SOLLIE OAKS SUBDIVISION, NGUYEN ADDITION TO

APPLICATION NUMBER 8 DATE March 20, 2008
APPLICANT Sollie Oaks Subdivision, Nguyen Addition to
REQUEST Subdivision

DETAIL SITE PLAN

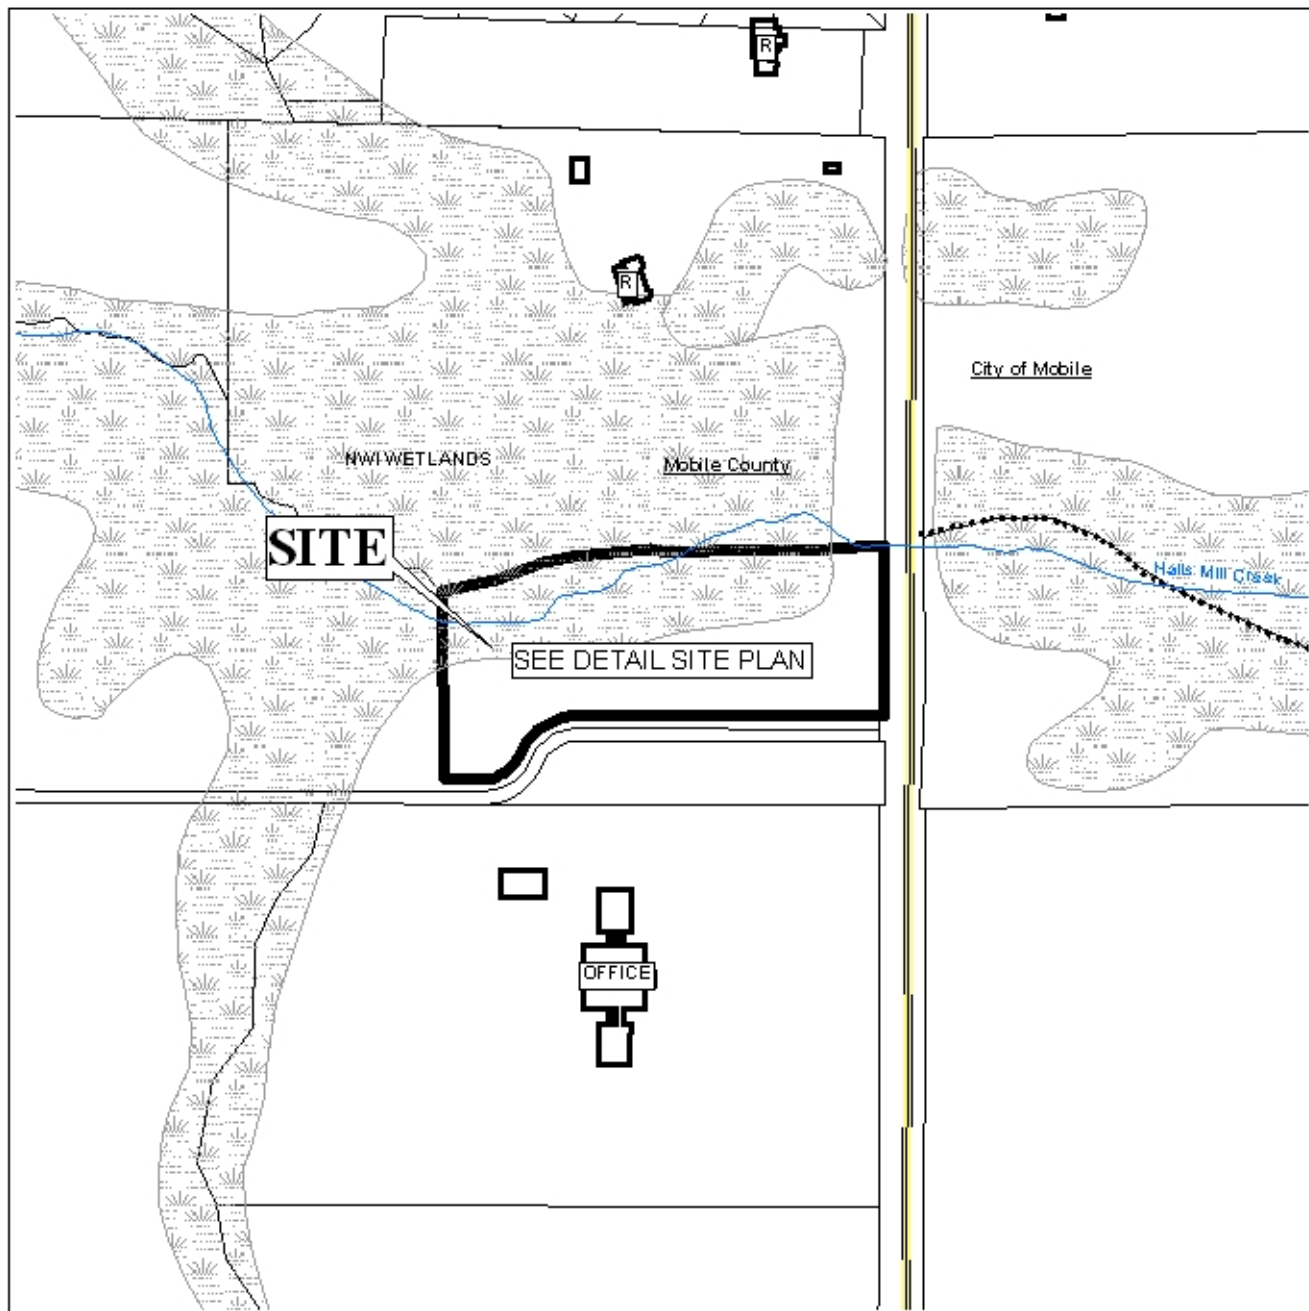
The purpose of this application is to create two legal lots of record from a metes and bounds parcel. It appears that the parcel was illegally divided out in 2006. The plat should be revised to include the remainder of the parent parcel in the subdivision. Furthermore, the parent parcel was included in the Sollie Oaks Subdivision, which was approved by the Planning Commission in its April 17, 2003 meeting, as proposed Lots 3 and 4. Lots 1 and 2 of Sollie Oaks were recorded in February of 2004 with the remainder (lots 3 and 4) labeled as future development. It should be pointed out that “lot 4” of the previous application was shown as “future development,” but in fact had and still has a single-family residence , thus is already developed. There was no extension filed, thus the approval has expired. It is recommended that this application be held over to allow the applicant to revise the plat to include the entire parcel in the subdivision or provide planning staff with a letter stating the owners of the remaining property do not wish to participate in the subdivision process.

- 1) revised plat to include the remainder of the parent parcel in the subdivision; and
- 2) submittal of new labels and postage required to re-advertise.
